Informal document No. **GRSG-88-13**  
(88th GRSG session, 18-22 April 2005.  
agenda item 1.4.)

## SAFETY OF WHEELCHAIR PASSENGERS IN BUSES

(GRSG adhoc working group on the safety of wheelchair passengers in road vehicles  
Working document following the 4th meeting in London)

Transmitted by the expert from the United Kingdom

Fig.  
Paragraph

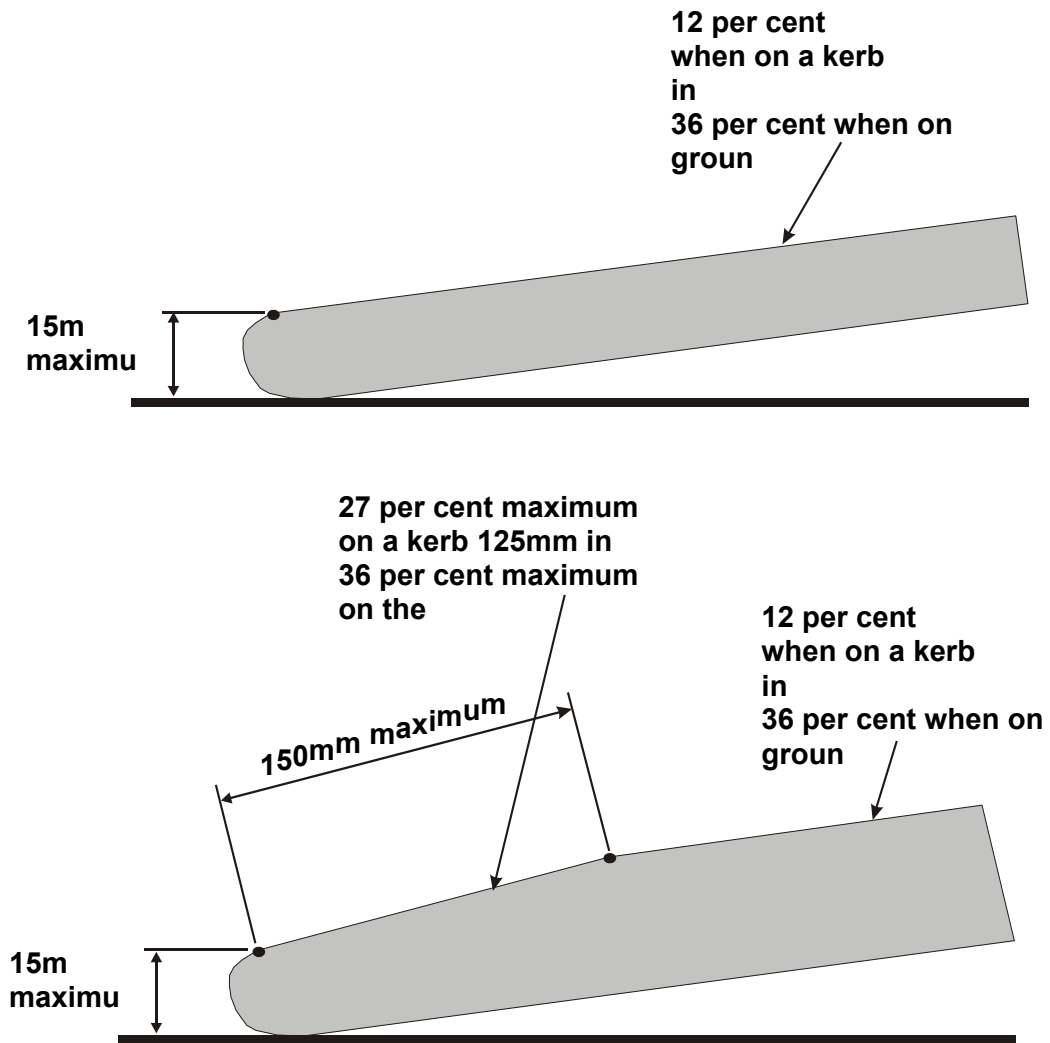
**3.11.4.1.7.1. AT THE POINT WHERE THE RAMP MEETS THE KERB OR GROUND IT IS POSSIBLE TO CONTACT THE MAIN SURFACE OF THE RAMP OR A TRANSITION SECTION LEADING TO THE MAIN SURFACE AS SPECIFIED IN 3.11.4.1.3. AT OR BELOW A PLANE PARALLEL TO, AND NOT EXCEEDING 15MM IN HEIGHT MEASURED ABOVE THE SURFACE OF THE KERB OR THE GROUND, THIS MUST BE ACHIEVED WITH THE RAMP RESTING ON A KERB 150MM IN HEIGHT AND WHEN RESTING ON THE GROUND. (SEE FIG A8/1);**

Fig. A 8/4  
Paragraph 3.8.4.

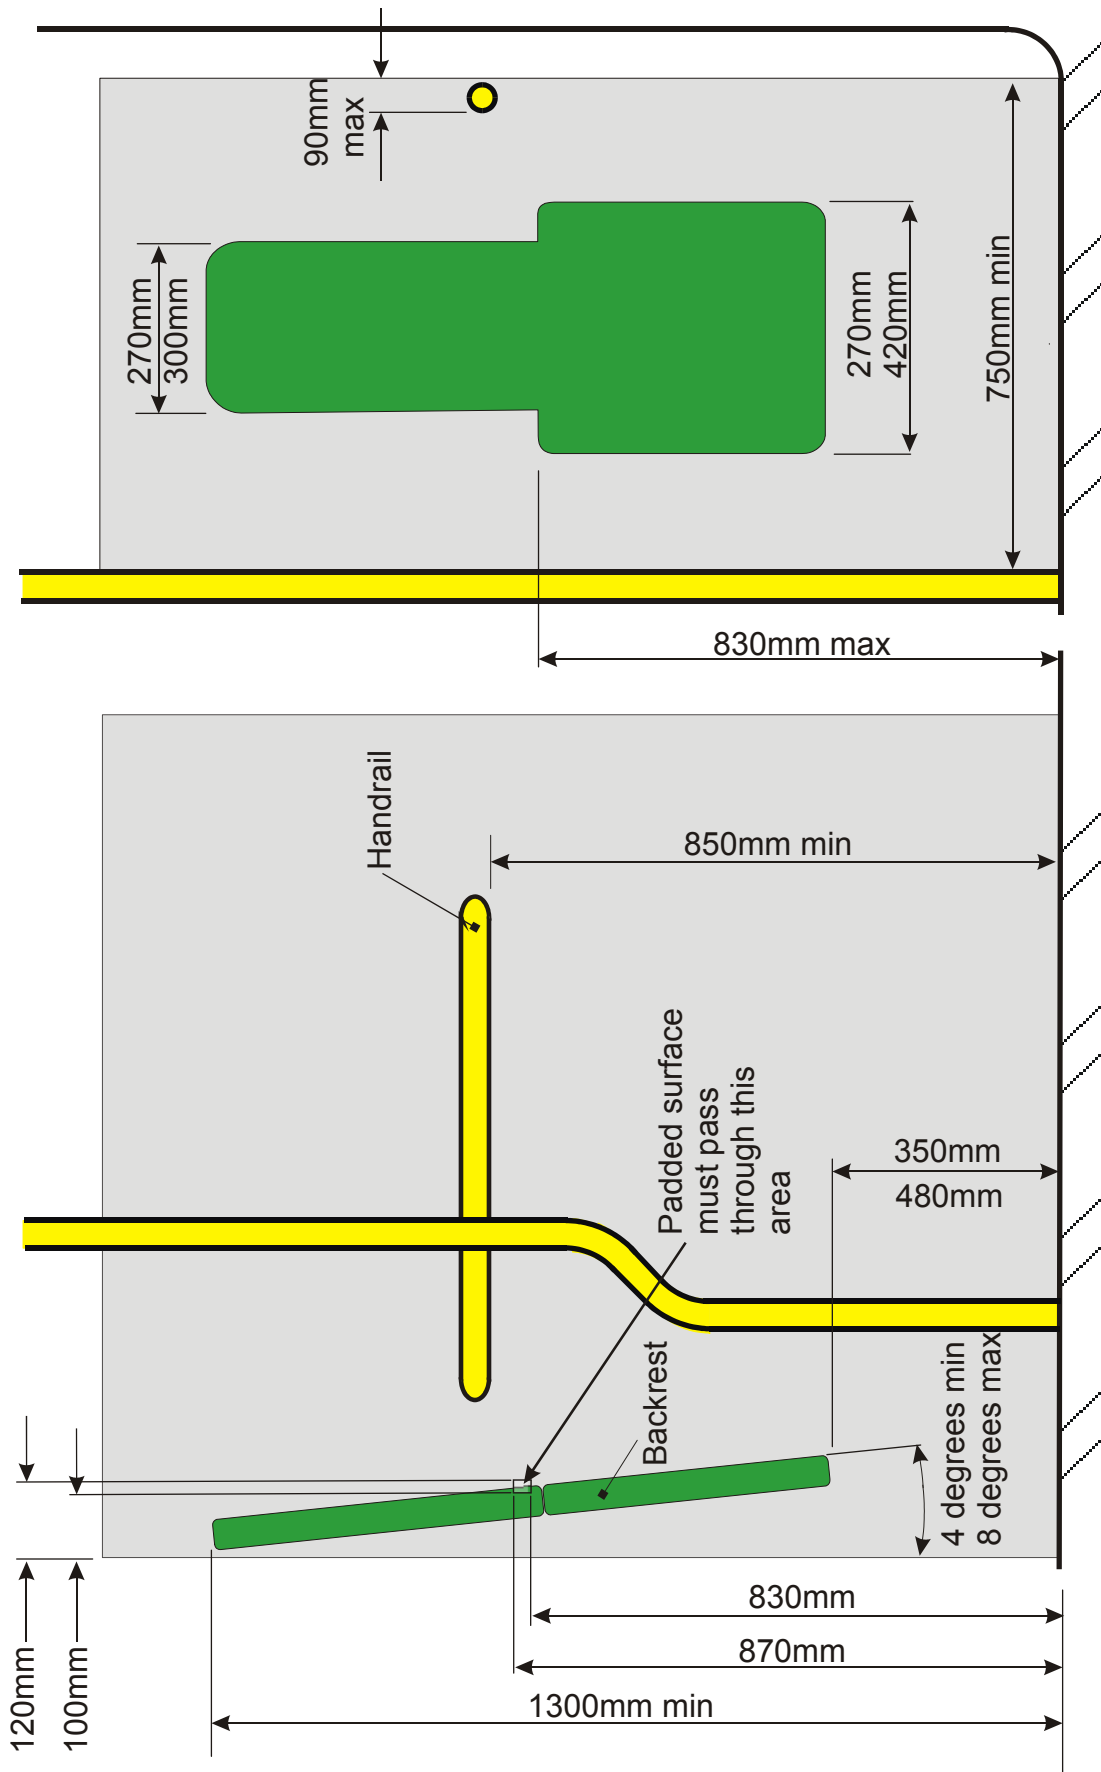
**3.8.5.5.        THE PADDED SURFACE OF A BACKREST SHALL FORM A SINGLE AND CONTINUOUS PLANE;**

**3.8.5.6.        THE PADDED SURFACE OF A BACKREST SHALL PASS THROUGH ANY POINT ON AN IMAGINARY VERTICAL PLANE SITUATED TO THE REAR OF THE FRONT END OF THE WHEELCHAIR SPACE AND SITUATED NOT LESS THAN 100 MM AND NOT MORE THAN**

**3.8.5.7. A BACKREST SHALL BE CAPABLE OF BEARING A LOAD OF 250 DAN ± 20 DAN APPLIED FOR A MINIMUM OF 1.5 SECONDS BY MEANS OF A BLOCK 200 MM X 200 MM SQUARE IN THE LONGITUDINAL PLANE OF THE VEHICLE TOWARDS THE FRONT OF THE VEHICLE TO THE CENTRE OF THE PADDED SURFACE OF THE BACKREST AT A HEIGHT OF NOT LESS THAN 600 MM AND NOT MORE THAN 800 MM MEASURED VERTICALLY FROM THE FLOOR OF THE WHEELCHAIR SPACE. THE BACKREST SHALL NOT DEFLECT MORE THAN 100 MM OR SUFFER PERMANENT DEFORMATION OR DAMAGE.**

**3.8.6. A SUPPORT, NOT BEING A BACKREST MEETING THE REQUIREMENTS OF 3.8.4.1. ABOVE SHALL BE PROVEN TO PROVIDE COMPARABLE LEVELS OF PROTECTION AS SUCH A BACKREST. IT SHALL BE ABLE TO WITHSTAND A FORCE OF 250DAN ± 20DAN PER WHEELCHAIR APPLIED IN THE HORIZONTAL PLANE OF THE VEHICLE AND TOWARDS THE FRONT OF THE VEHICLE IN THE MIDDLE OF THE SUPPORT. THE FORCE SHALL BE MAINTAINED FOR A PERIOD OF NOT LESS THAN 1.5 SECONDS.**
